## ADDENDUM #1

- A. Project Name: **Downtown Parking Garage.**
- B. Owner: **City of Winter Garden**
- C. Owner Project Number: **AS15-13012**
- D. Design Criteria Professional: **Walker Parking Consultants / Engineers, Inc.**
- E. Design Criteria Professional's Project Number: **15-1995.00**
- F. Date of Addendum: **April 9, 2015**

**C001**

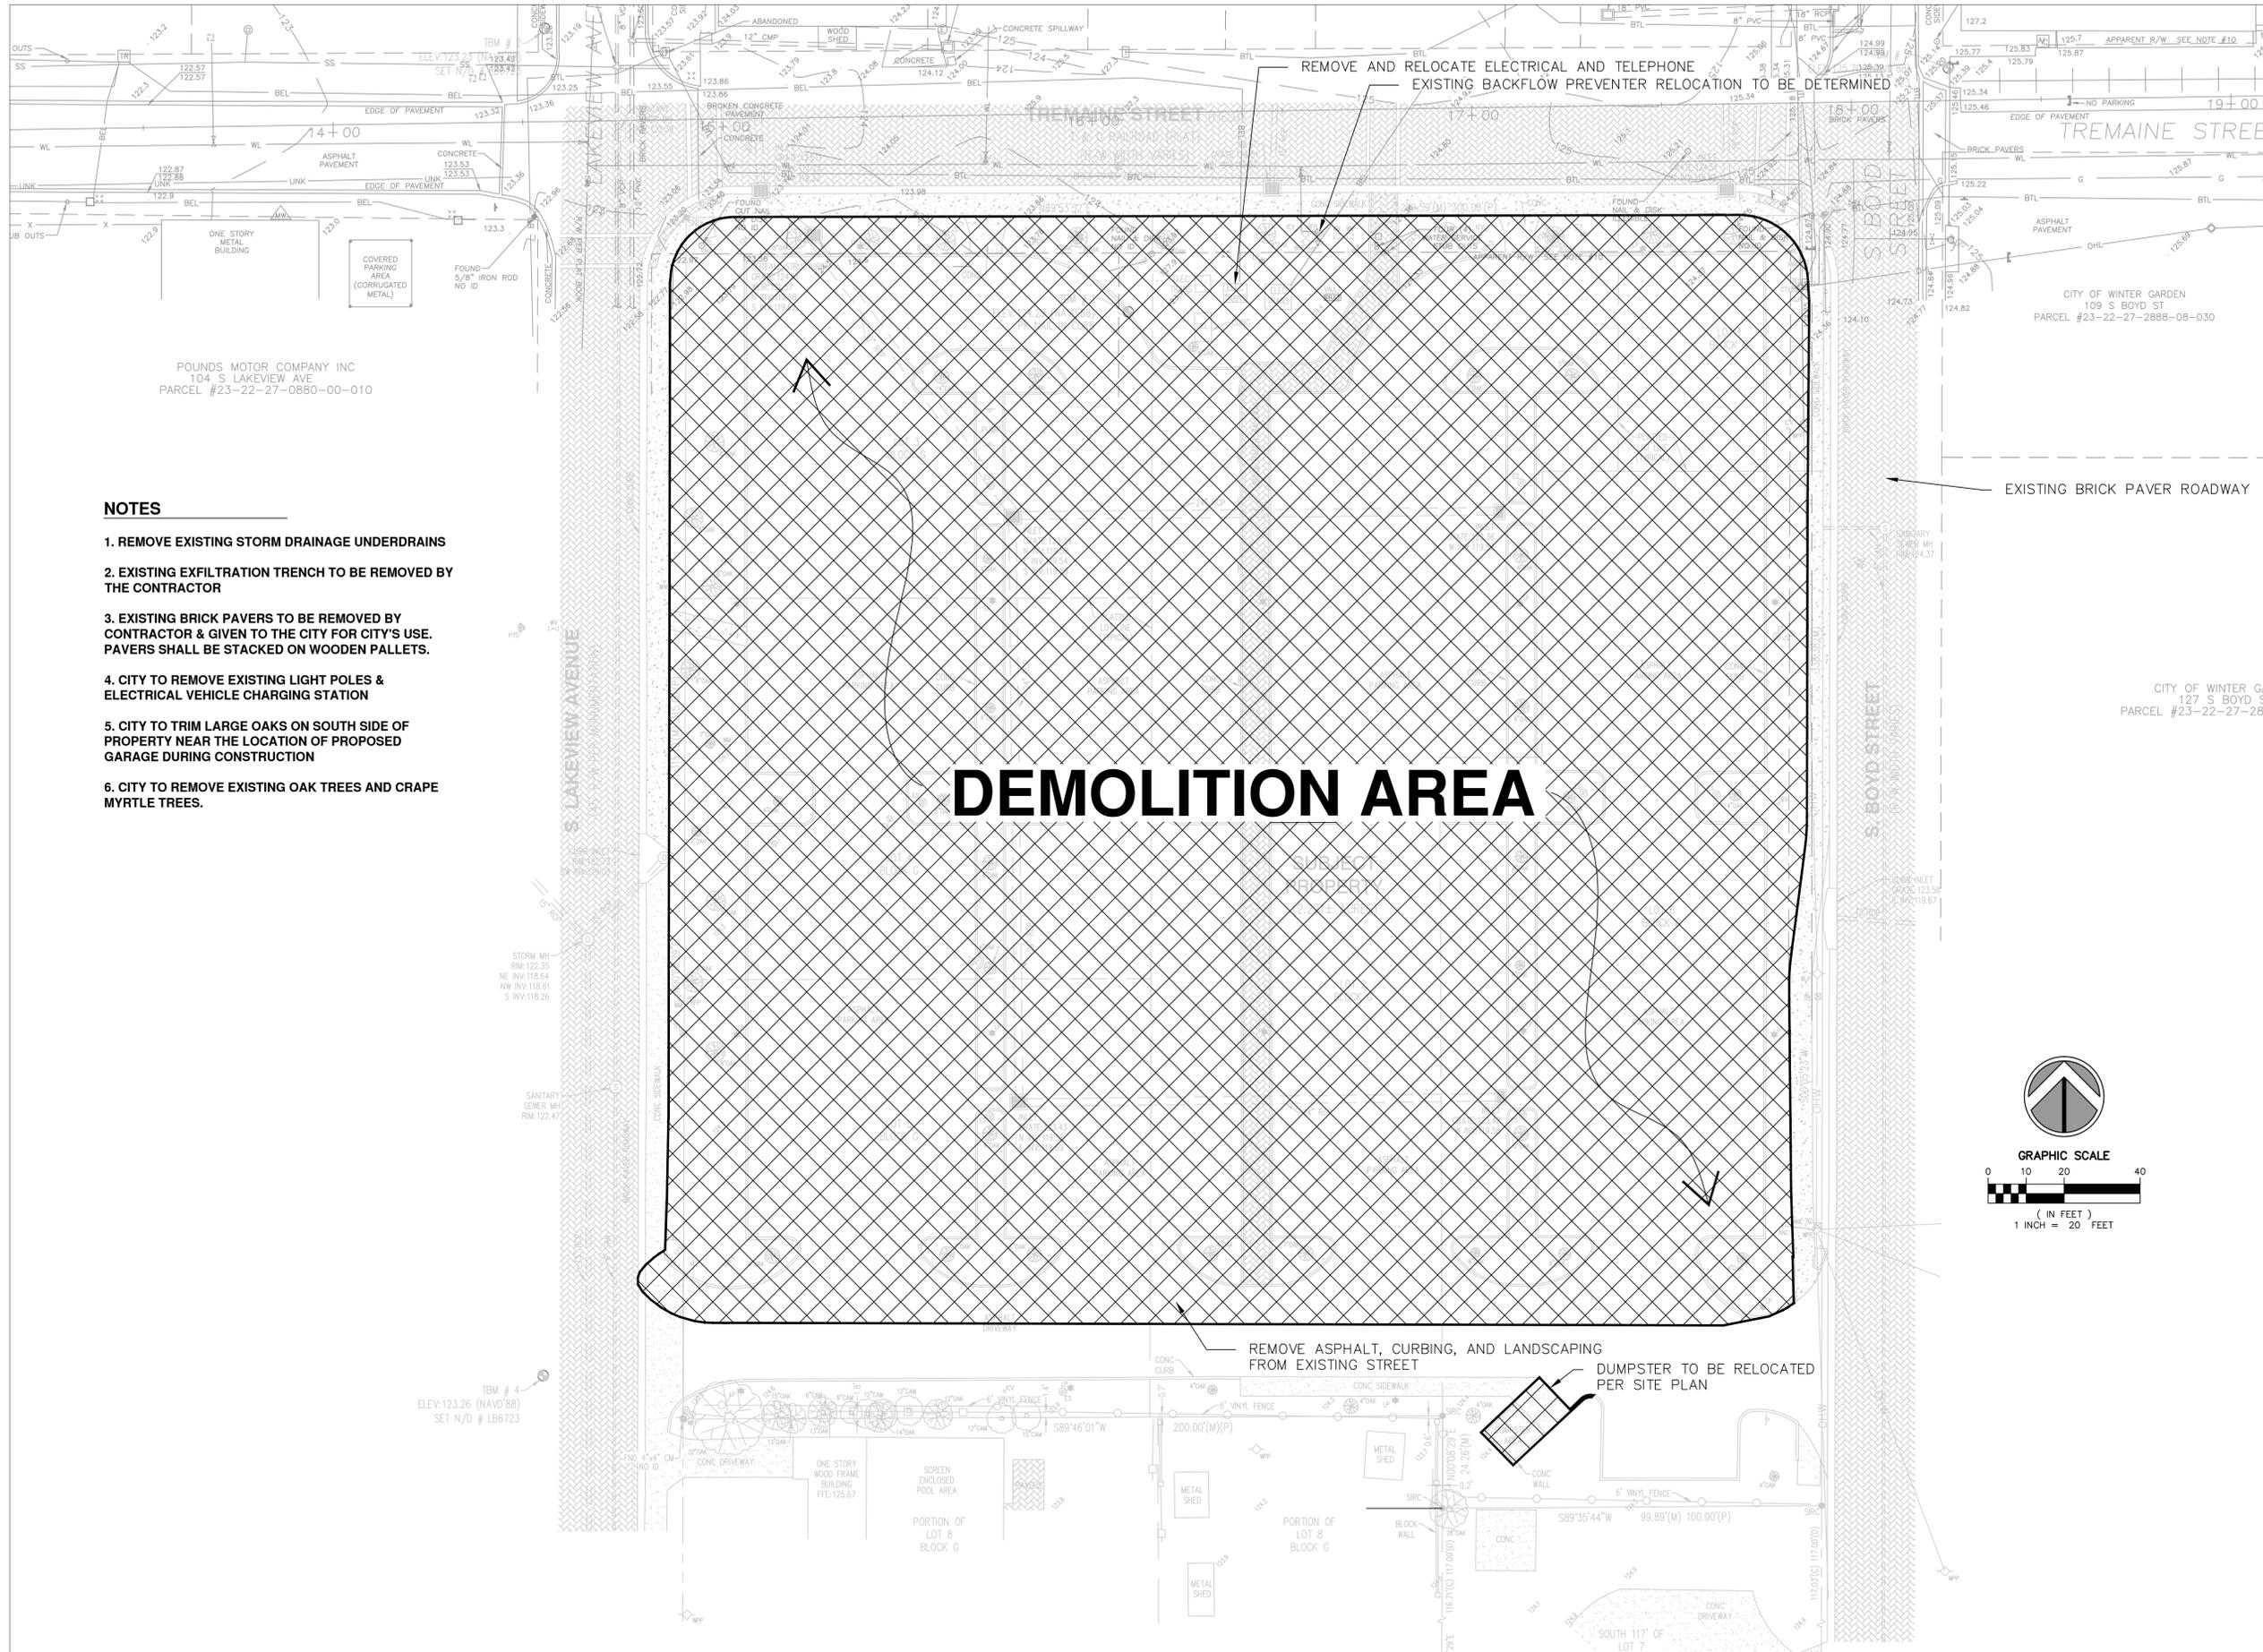
1. REMOVE EXISTING STORM DRAINAGE UNDERDRAINS
2. EXISTING EXFILTRATION TRENCH TO BE REMOVED BY THE CONTRACTOR
3. EXISTING BRICK PAVERS TO BE REMOVED BY CONTRACTOR & GIVEN TO THE CITY FOR CITY'S USE. PAVERS SHALL BE STACKED ON WOODEN PALLET.
4. CITY TO REMOVE EXISTING LIGHT POLES & ELECTRICAL VEHICLE CHARGING STATION
5. CITY TO TRIM LARGE OAKS ON SOUTH SIDE OF PROPERTY NEAR THE LOCATION OF PROPOSED GARAGE DURING CONSTRUCTION
6. CITY TO REMOVE EXISTING OAK TREES AND CRAPE MYRTLE TREES.

**SITE/UTILITY PLAN**

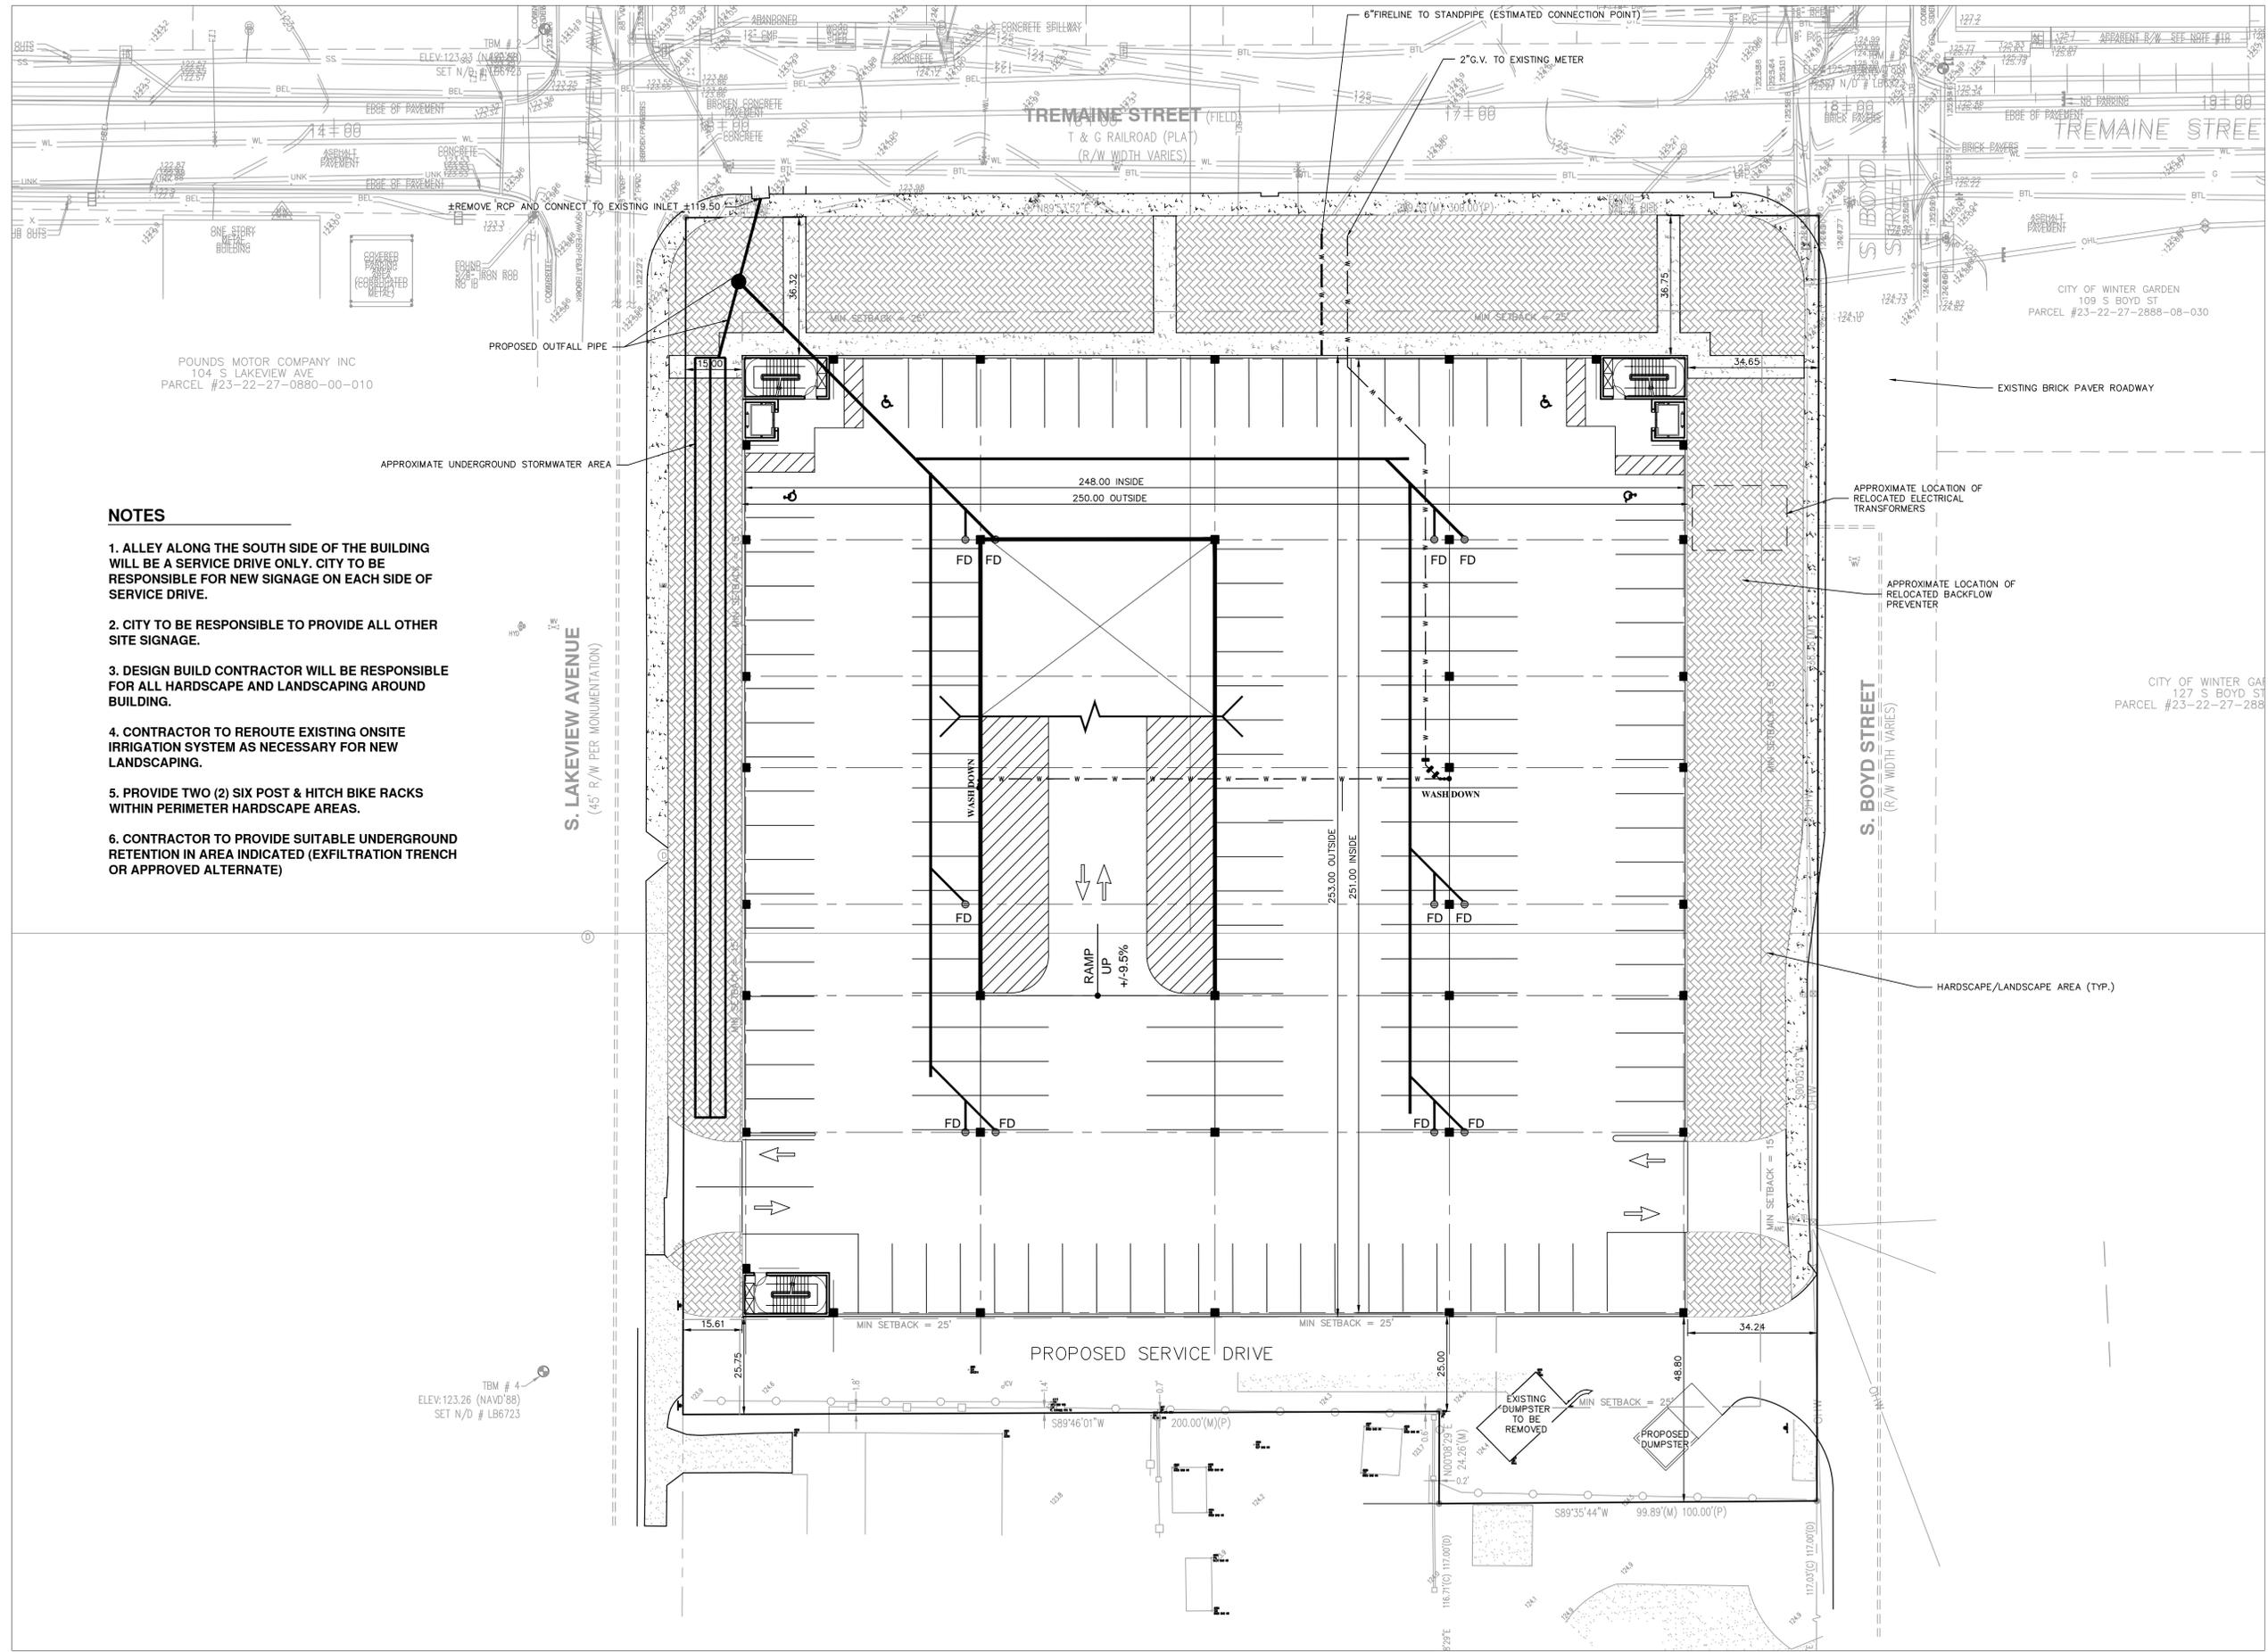
12. Is there a preferred location for the 2 bike racks, noted on C002?  
Response: Up to the Designer
13. Are there any provisions for closing the garage - OH coiling grilles, security screens at 1st, etc.

23. The alley to the south shows one-way traffic to the east but the dumpsters face to the east. Is this the intent?

Response: Refer to reissued site plan C002. It is a service drive only.

1. ALLEY ALONG THE SOUTH SIDE OF THE BUILDING WILL BE A SERVICE DRIVE ONLY. CITY TO BE RESPONSIBLE FOR NEW SIGNAGE ON EACH SIDE OF SERVICE DRIVE.
2. CITY TO BE RESPONSIBLE TO PROVIDE ALL OTHER SITE SIGNAGE.
3. DESIGN BUILD CONTRACTOR WILL BE RESPONSIBLE FOR ALL HARDSCAPE AND LANDSCAPING AROUND BUILDING.
4. CONTRACTOR TO REROUTE EXISTING ONSITE IRRIGATION SYSTEM AS NECESSARY FOR NEW LANDSCAPING.
5. PROVIDE TWO (2) SIX POST & HITCH BIKE RACKS WITHIN PERIMETER HARDSCAPE AREAS.
6. CONTRACTOR TO PROVIDE SUITABLE UNDERGROUND RETENTION IN AREA INDICATED (EXFILTRATION TRENCH OR APPROVED ALTERNATE)
